MFN 06-191
Supplement 3

Subject: Response to Portion of RAI Letter No. 38 Related to ESBWR Design Certification Application - Seismic Category I Structures - RAI Numbers 3.8-3 S03, 3.8-6 S02, 3.8-13 S03, 3.8-14 S02, 3.8-18 S02, 3.8-20 S01, 3.8-25 S03, 3.8-26 S01, 3.8-27 S02, 3.8-41 S03, 3.8-46 S02, 3.8-48 S03, 3.8-51 S03, 3.8-56 S01, 3.8-64 S03, 3.8-87 S02, 3.8-90 S02, 3.8-91 S03 & 3.8-100 S02- Supplement 3

Response to Portion of RAI Letter No. 38

Seismic Category I Structures

Figure 3.8-3 (1)

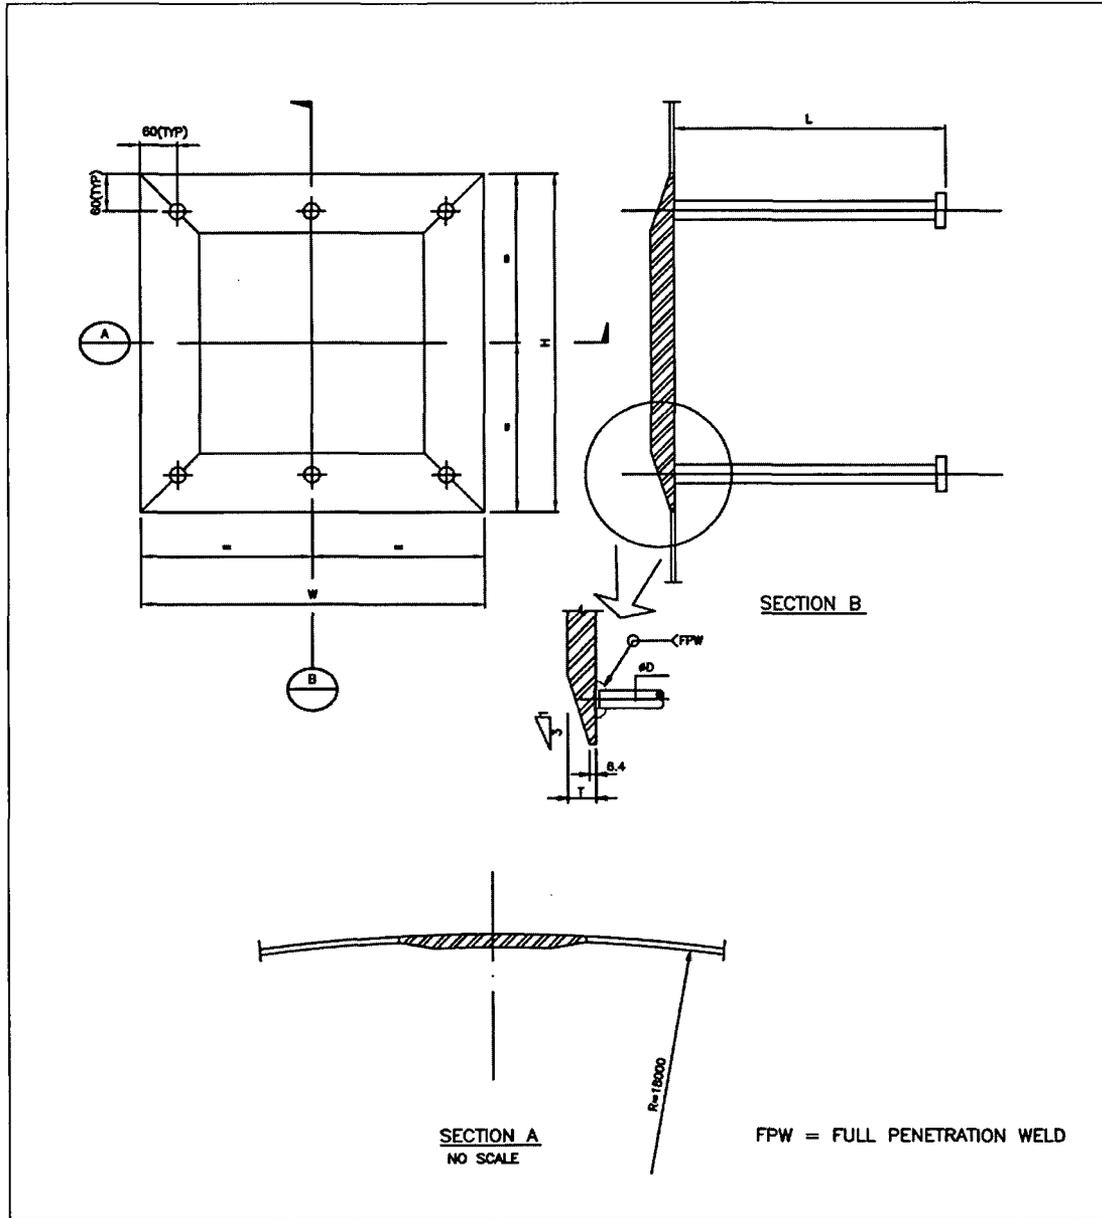
- a) *Describe embedded plates to support steel members inside containment and show sketch of interaction with liner plate.*
- b) *Describe embedded plate support steel members (from pipe whip restraints; piping supports; etc) outside containment and show sketches with anchors into concrete containment.*
- c) *Describe diaphragm connection to containment and reference DCD figures as appropriate. Indicate whether fixed ended or simply supported and type of weld to be used (FP;FW; etc)*
- d) *Provide description and sketch of a typical embedded plate outside containment that supports commodity items like ducts, trays, conduits, etc.*

- a) Regarding steel members such as structural steel shapes, piping supports or commodity supports inside containment, Figure 3.8-3 (1) below shows a typical support plate with anchors embedded in the concrete containment. The dimensions of the plate and the number of anchors depend on the loads for each support. They are designed in accordance with ANSI/AISC N690 and ACI 349 Appendix B.

Figure 3.8-3 (3) - Refueling seal: Comparison of compressed and extended bellows.

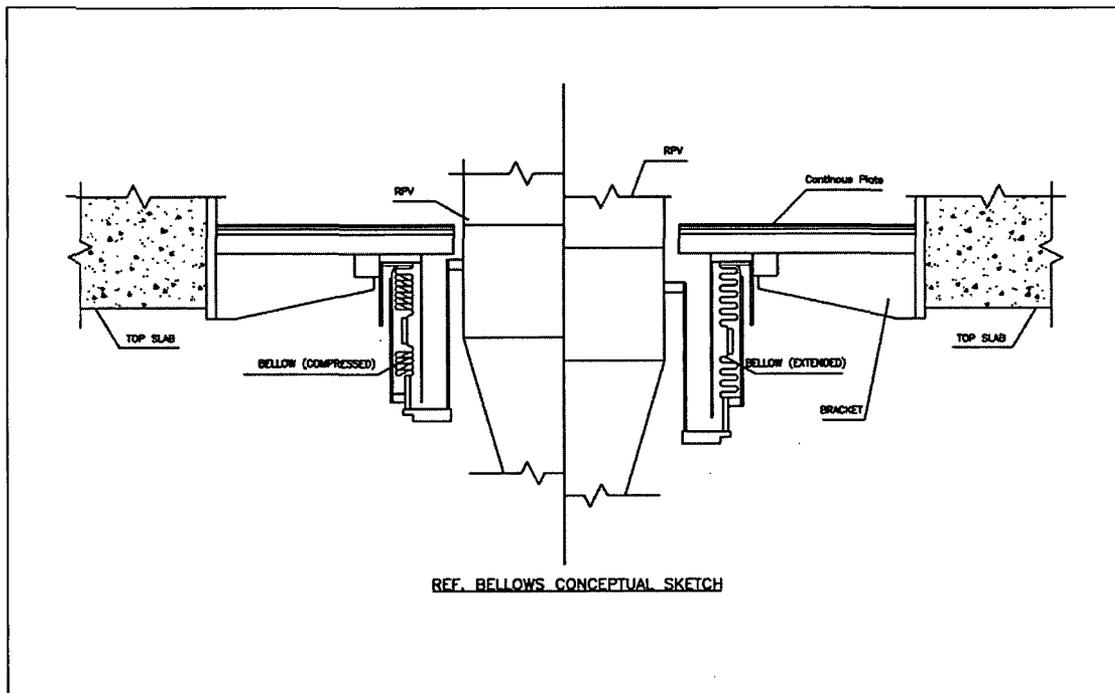
- a. *Provide conceptual design detail of RPV stabilizer.*
- b. *Provide conceptual design detail of Refueling Seal.*

- a. See RAI 3.7-27, Supplement 1.
- b. See Fig. 3.8-3 (3) for conceptual design details of the Refueling Seal.

Figure 3.8-13 (1) Comparison of Basemat Deformation for Dead Load

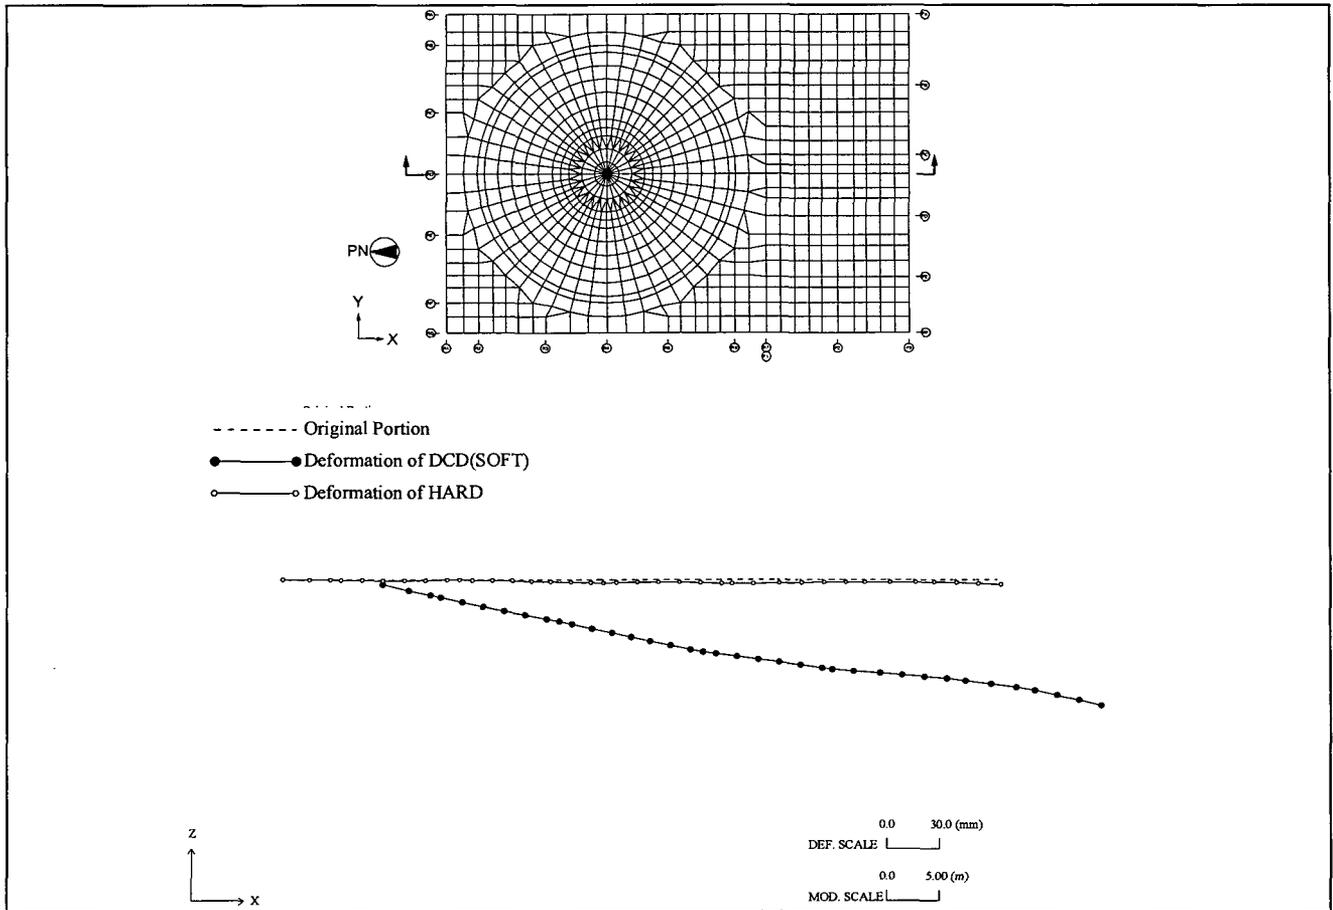
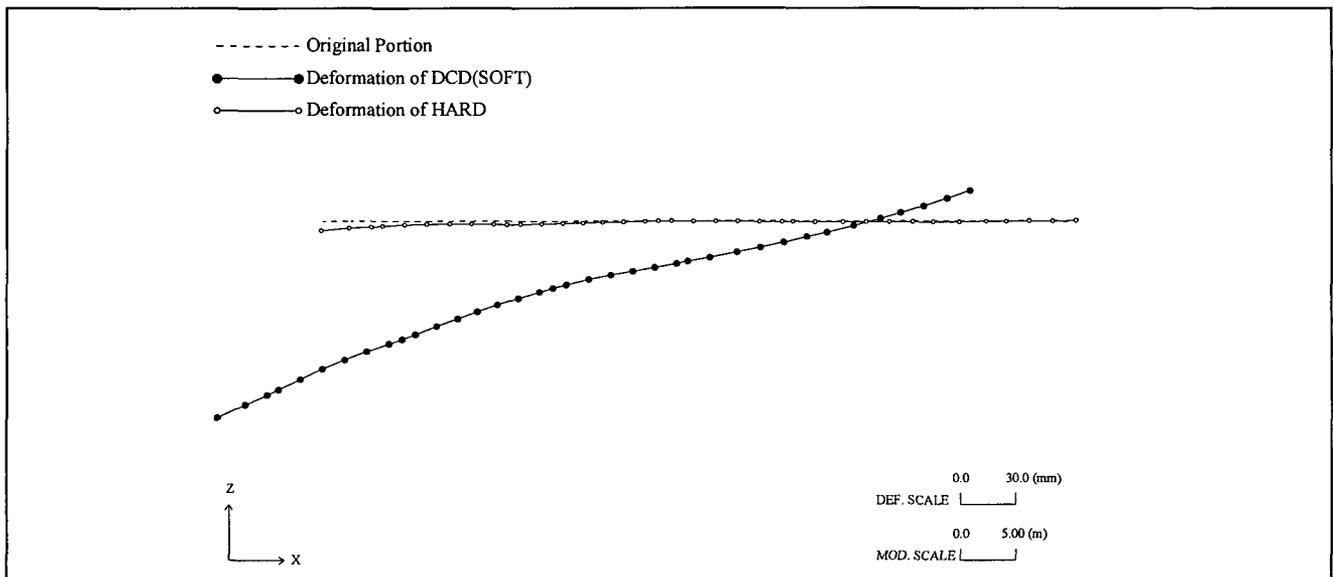
- a) *The part (a) response needs clarification and possible revision of the DCD to describe/explain how the dynamic stick model results for multiple soil cases were used to develop the statically applied seismic loads used in the NASTRAN model. How was conservatism verified?*

Figure 3.8-13 (1) shows the sectional deformations of the basemat. Figures 3.8-13 (2) and (3) compare the bending moments generated in the basemat. Basemat deformation for the soft soil condition is much larger than that of the hard rock condition. As for bending moments, their magnitudes for the soft soil are larger than those for the hard rock, in general. The higher bending moments at few locations for the hard rock site has no impact on the design since they are much less than the maximum moments of the soft soil site on which rebar sizing is based.

There are some soil springs present in Figure 3.8-13 (1) that are in tension for the South to North seismic case. This section evaluates the impact on basemat stresses without these soil springs in tension under the soft soil condition.

Figure 3.8-13 (6) Comparison of Basemat Deformation without Tension Springs

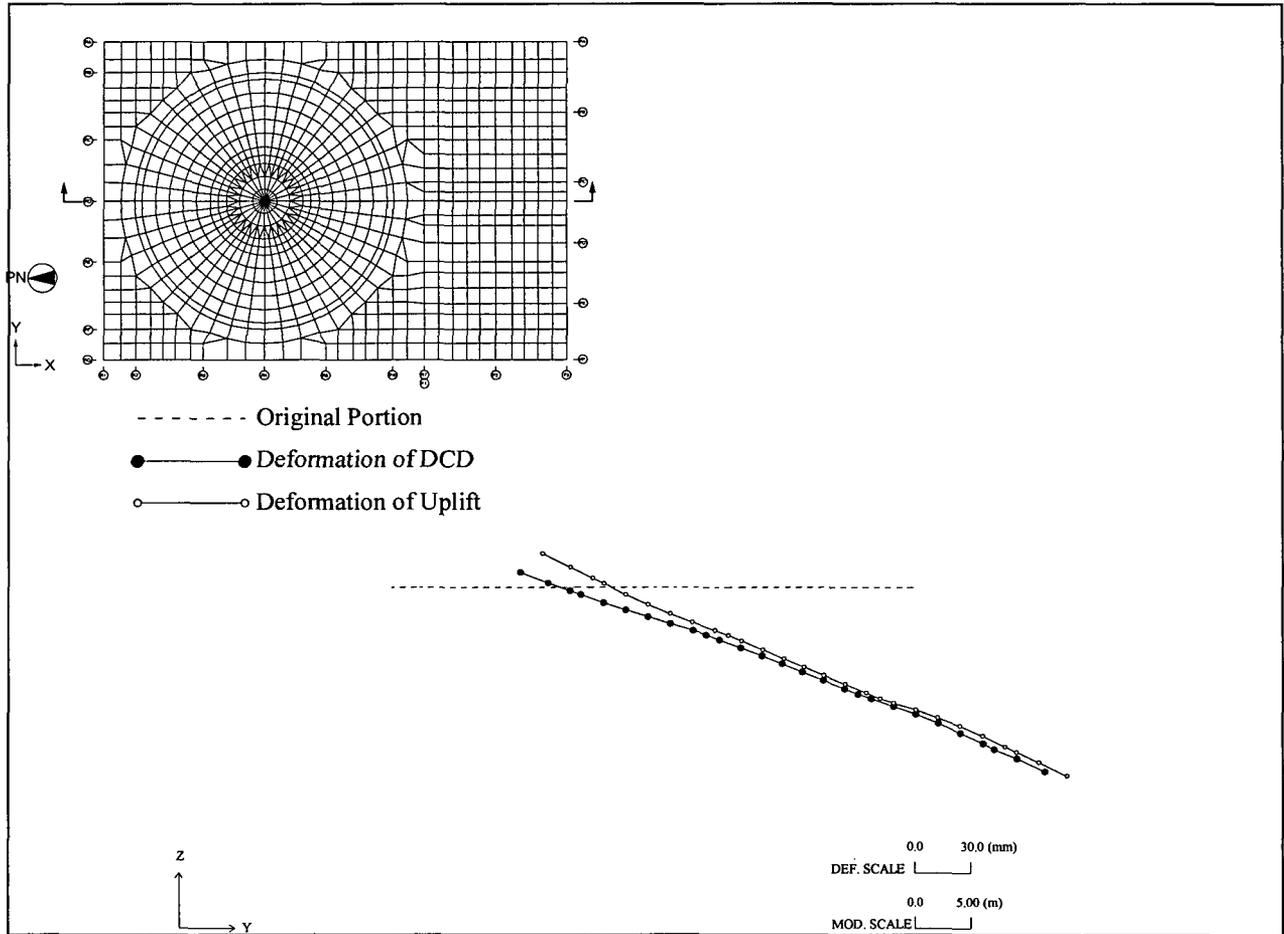
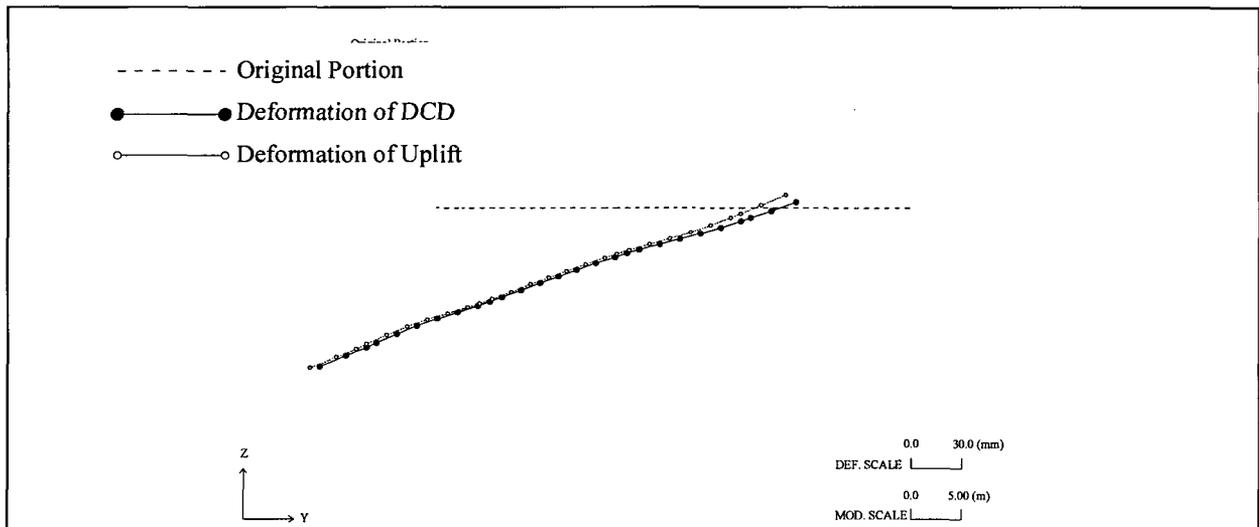
Supplement 1 showed only seismic loading in N-S direction. Provide results for seismic loading in 3 directions.

Figures 3.8-13 (6), (7) and (8) show the comparison of the sectional deformations of the basemat and bending moments generated in the basemat respectively at the final step of iteration. In the area close to the cylindrical wall below the RCCV wall, bending moments are higher than that of DCD design; however the resulting stresses in the concrete and reinforcement are still below the code allowables with large margins as shown in Table 3.8-13 (4). Stress calculations in Table 3.8-13 (4) were performed for the following combinations to consider the effects of three directional inputs:

Figure 3.8-14(1) Analyzed Section (Plan, DW)

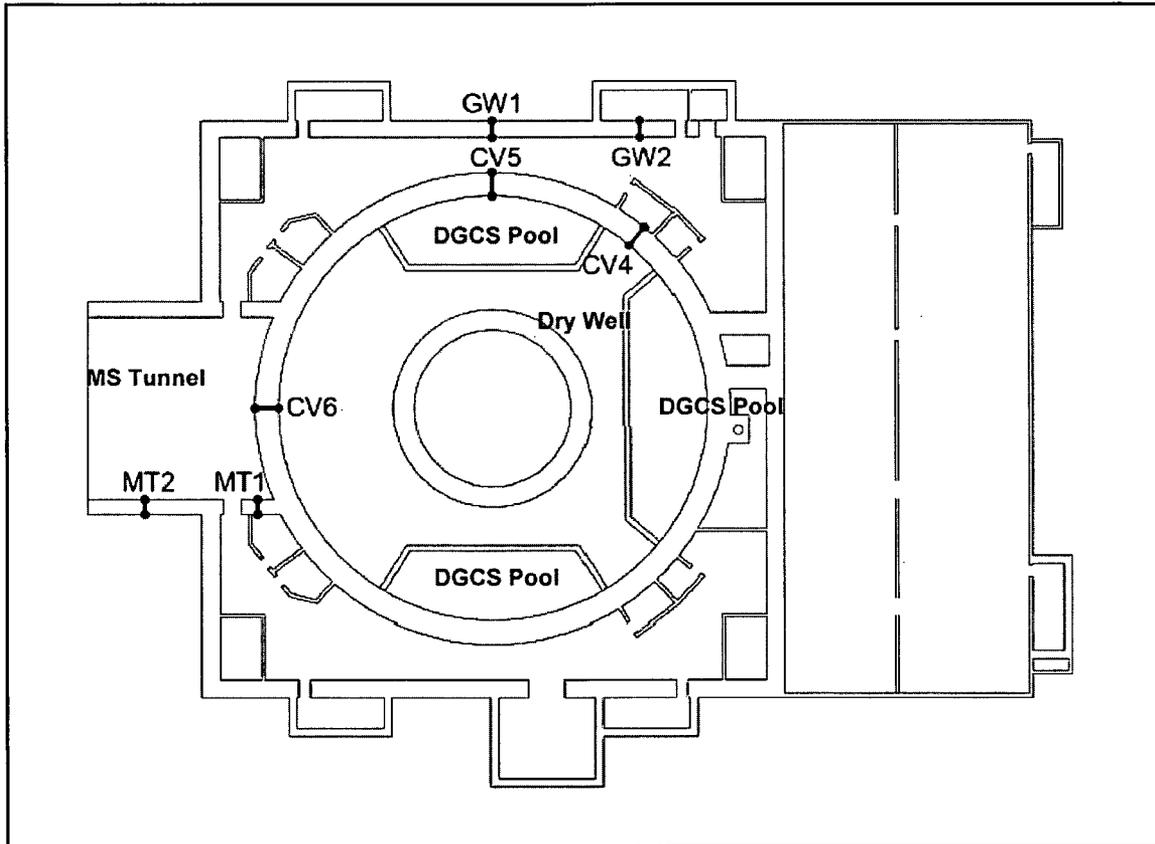
During the audit, GE provided a draft supplemental response to address the part b) item. Describe the type of model used for this particular study (e.g., 3-D, finite element brick elements of the RB using what computer program). Clarification is needed for Figure 3.8-14(4) - stress or force (Ny) and Table 3.8-14(1) force and moment across entire section?

Evaluation is performed for the general portion of the RCCV Drywell, which is shown as CV4 in Figure 3.8-14(1). Figure 3.8-14(2) shows the temperature distribution in section CV4 for the Winter condition. It is taken from a 2D transient temperature distribution analysis, using computer code TEMCOM2, as described in DCD Tier 2 Section 3C.5, assuming an equivalent linear temperature distribution. Two cases are selected: 6 minutes and 72 hours after DBA. Figure 3.8-14(3) shows Young's Modulus (E) distributions across the section in terms of equivalent linear temperature and average temperature. The reduction factor of E for concrete is shown in DCD Tier 2 Section 3G.1.5.2.3.1.

Figure 3.8-27 (2)

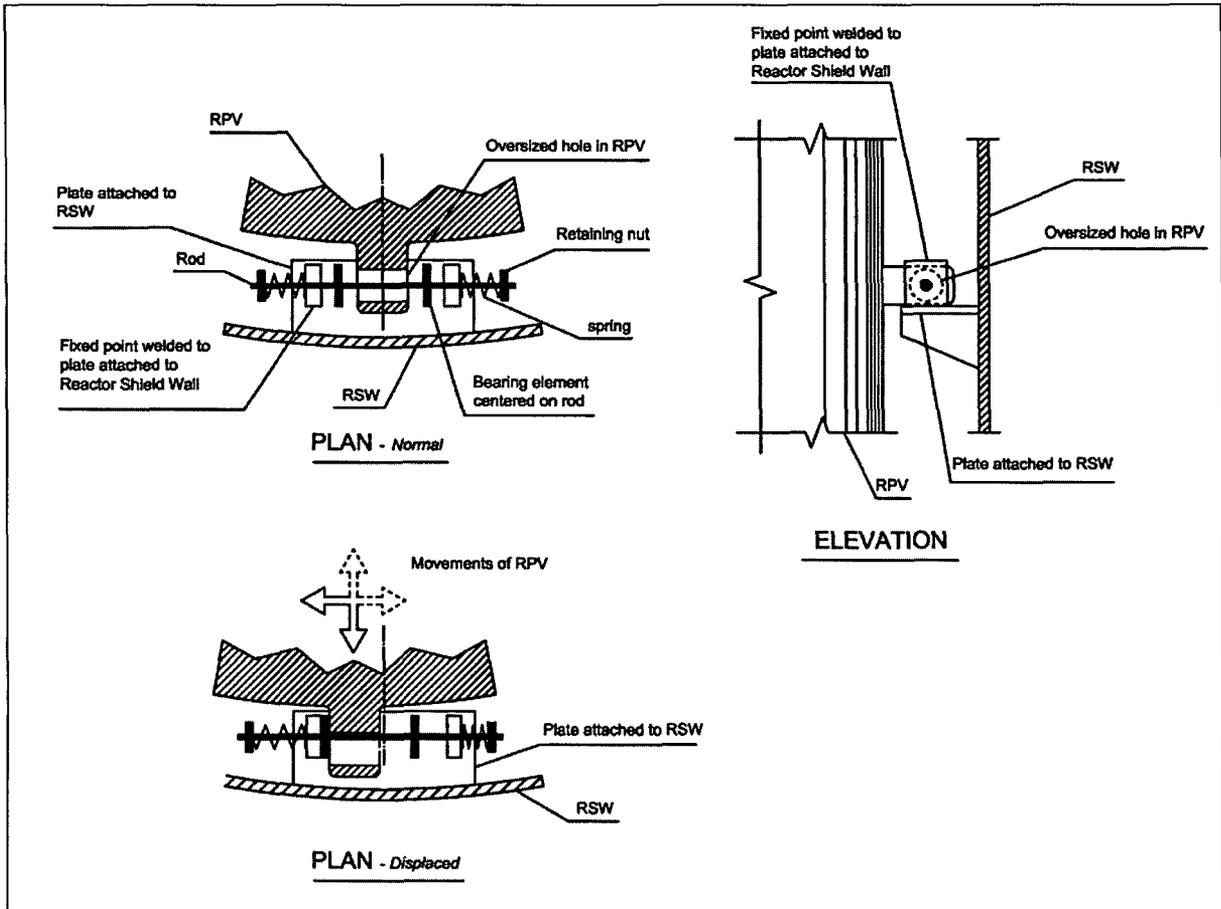
a) Acceptable (the analysis & design is addressed separately under RAI 3.8-17). b) From Fig. 3.8-27(2), the RPV stabilizer attachment to the SW does not appear to provide free radial movement, and it is not obvious how it provides lateral (i.e., tangential direction) restraint, since springs and gaps are provided for tangential movement. Please explain. Also, include the descriptions and sketches/details provided with the RAI response for both items in the DCD.

- b) Refer to Figure 3.8-27 (2) for details of the RPV Stabilizer concept to be used in eight places in the ESBWR.

Figure 3.8-100 (1) Section of Basemat (DCD Design)

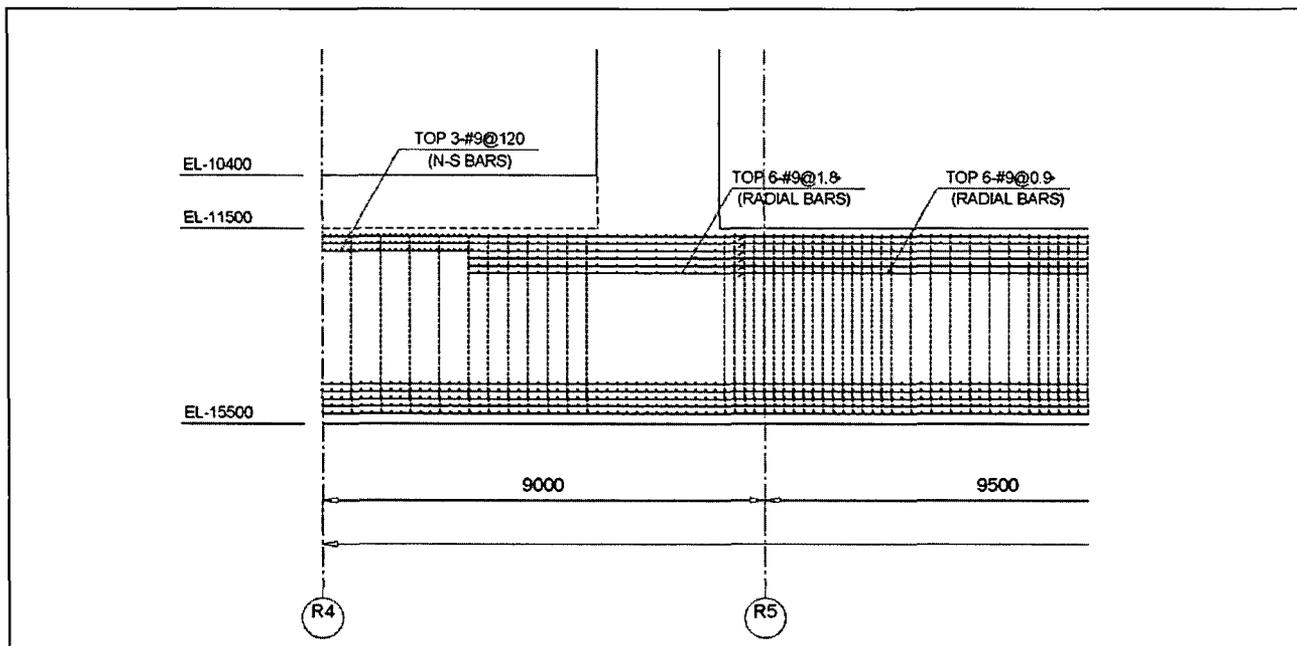
GE shows that the bending moments increase almost 30 % at the center due to the larger basemat thickness at the center. Since GE's primary reinforcement design is based on a 4 m depth as shown in Figure 3.8-100 (1), the effective height of the section for reinforcement design does not increase, therefore the amount of reinforcing steel required should increase. GE needs to clarify the bases for the reinforcement design in the light of their study. Also, GE needs to explain the technical bases for determining the size of the reinforcing bars in the top surface of the thickened portion to prevent the development of concrete cracking. This response needs to be coordinated with the results of BNL's confirmatory analyses.

In the current DCD design, basemat rebars are arranged in a straight line at the region of the RCCV center. (See Figure 3.8-100 (1).) In this rebar arrangement, concrete located far from top rebars such as under the lower drywell is conservatively neglected in the structural design. This concrete would be poured after the completion of basemat and RPV pedestal structural components.

In light of these concerns, the arrangement shown in Figure 3.8-100 (1) was selected for the DCD design.
